IN THE DRAWINGS:

Please replace Figure 27A with the corrected Figure 27A shown on the attached Replacement Sheet.

REMARKS

FIG. 27A

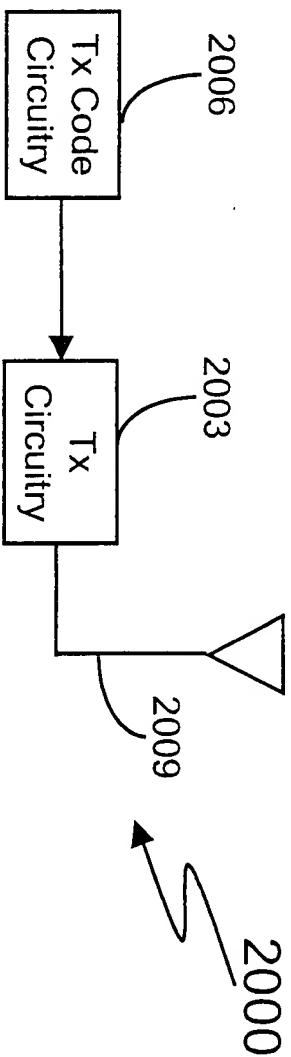
The drawings were objected to by the Examiner. In particular, figure 27A is objected to regarding the use of "Tx Circuitry 2035" where the Examiner believes "Pulse Circuitry 2035" should be used.

In the corrected figure 27A, submitted herewith, circuitry 2035 is labeled Pulser Circuitry. Accordingly, withdrawal of this objection is respectfully requested.
